Product Change Notice (PCN)

PCN Number: PCN-0103214R-01

Product(s) Affected: SMI-AU-1

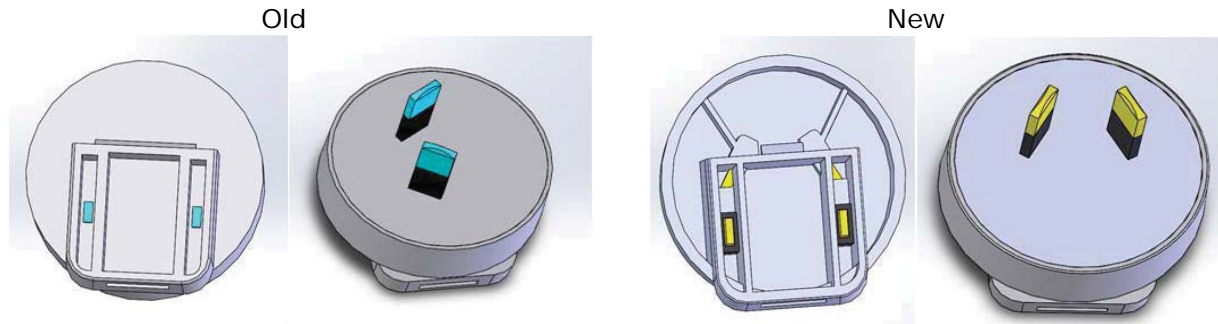
Description of Change: AU multi-blade adapter blade will change from two-piece ultrasonic welded construction to a one-piece molded form.

Primary changes will be distinguished aesthetically on the back (connection side) of the blade, and the orientation of the blades have changed 90 degrees.
